To: Chief Executive, Hutt City Council

1. This is a submission from Richard Kelly on the Proposed Lower Hutt District Plan 2025.
2. My email address for service is richard.kelly@outlook.co.nz.
3. I could not gain an advantage in trade competition through this submission.
4. The specific provisions of the proposal that my submission relates to, my submission on those provisions, and the decisions I seek are shown below. I also seek all further, alternative, necessary, or consequential relief as may be necessary to fully achieve the relief sought in this submission.
5. I wish to be heard in support of my submission.
6. If others make a similar submission, I will consider presenting a joint case with them at the hearing.

7. Flood analysis

Figure 1

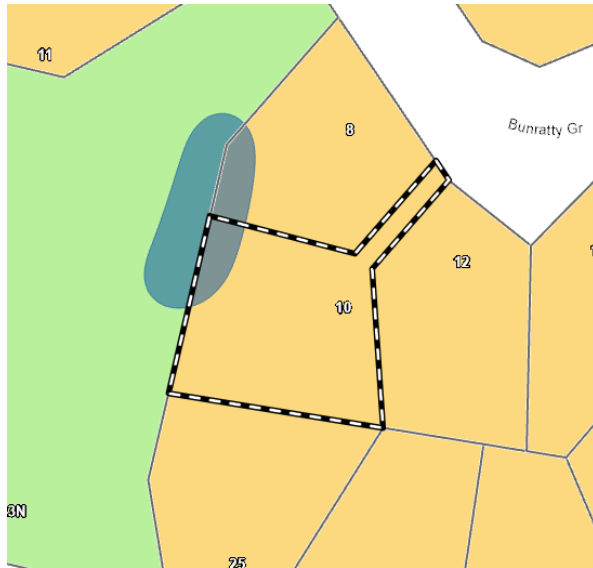
The modelling used to identify a high natural hazard area for proposed district plan must be flawed. The area shown in figure 1 is definitely not a high natural hazard area, is not prone to flooding, has never flooded in the 16 years I have owned the property or indeed in recorded or pre-history I cannot find evidence of a flood in this spot.

Please remove 10 Bunratty Grove, Wainuiomata from the proposed district plan changes as this is not a high natural hazard area, is not prone to flooding, has never flooded in the 16 years I have owned the property or indeed in recorded or prehistory, this area has never been a flood plain.

Figure 2

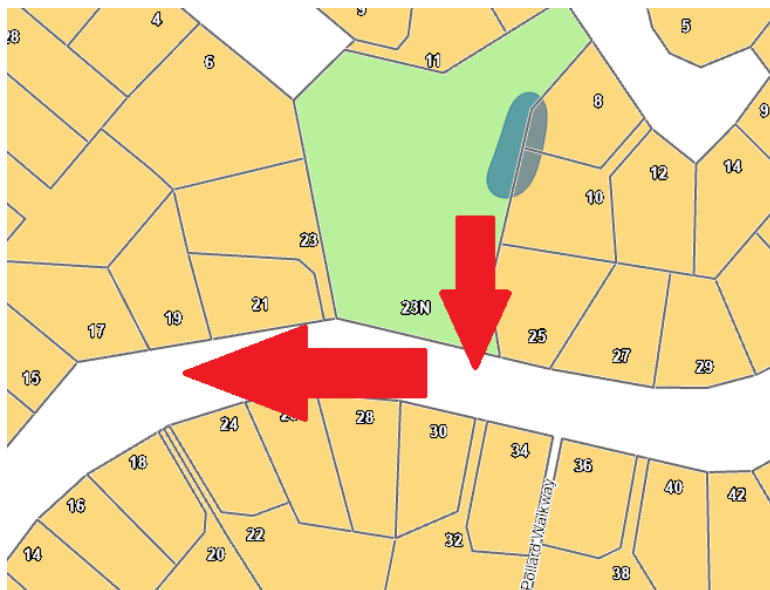
The water can't pool here because there is a downhill slope to Antrim crescent, then a downhill slope down Antrim crescent to Castlereigh Road. While I have had neither the time nor the money to conduct a profile survey, from an eyeball assessment the red arrows represent substantial grades of about 5%.

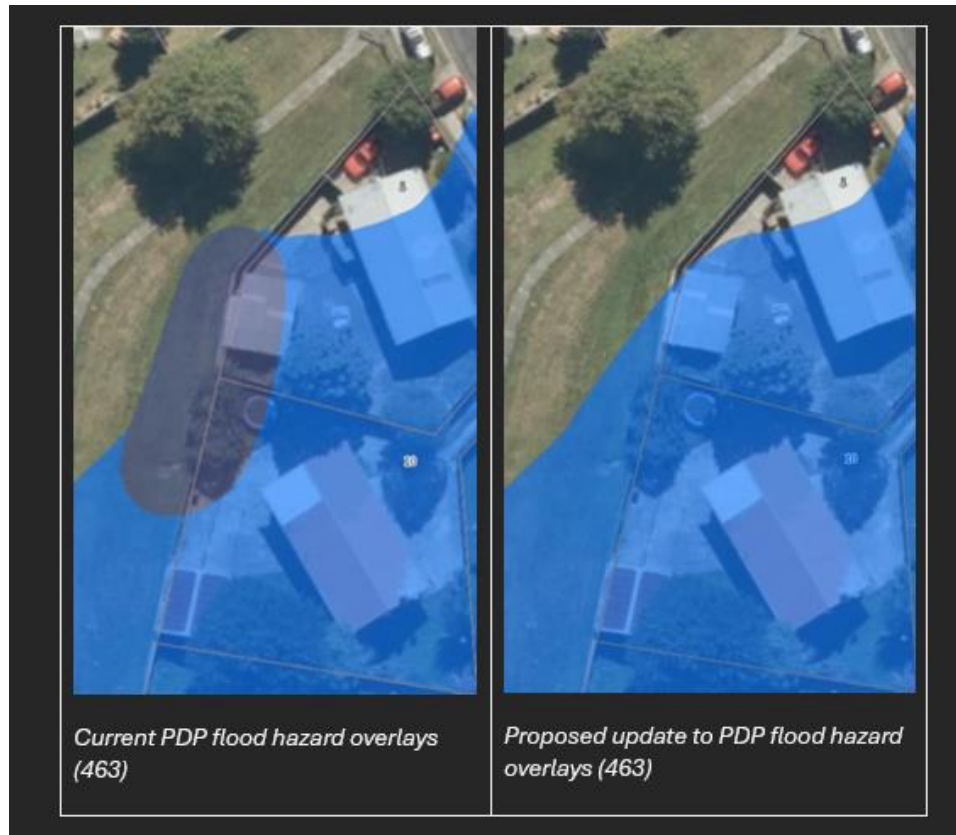
The flood hazard overlays presented in the Proposed District Plan (PDP) have been generated following the Greater Wellington Flood Hazard Planning Guidance document. Alongside the depth and velocity thresholds presented in the Guidance document, stream corridors (High Hazard category) have been manually generated from multiple sources including modelled streams, Tiaki Wai stormwater asset data, and the review of aerial photography. The stream

corridor that intersected 10 Bunratty Grove was generated from the Tiaki Wai asset data, which shows a short reach of stormwater open channel at this location. The detailed, site-specific review, initiated by the PDP submission process, showed that there is not a stream at the location and it does not appear to have historically been a stream, resulting in the recommendation to remove the stream corridor. It is likely the misrepresentation of the channel as a stream was not picked up during the development of the flood hazard overlays because there are multiple short reaches of stream corridor across Wainuiomata and the other HCC catchments, so it would not have appeared as unusual.

- The high flood hazard overlay is only present because the short stormwater drain in the reserve adjacent to the submitter's property has been designated as a stream corridor.

- I agree with the submitter that this drain should not represent a stream corridor, and the model results in the area do not reach depths or speeds that would be classified as high or medium hazard as per the hazard classification guidance document.

- I recommend removing the high flood hazard overlay at this location and replacing it with the low hazard overlay.
- Below are images of the current PDP flood hazard overlays and proposed updates relative to this submission.

Low hazard overlay should be removed and replaced with no hazard overlay as in the park next door.
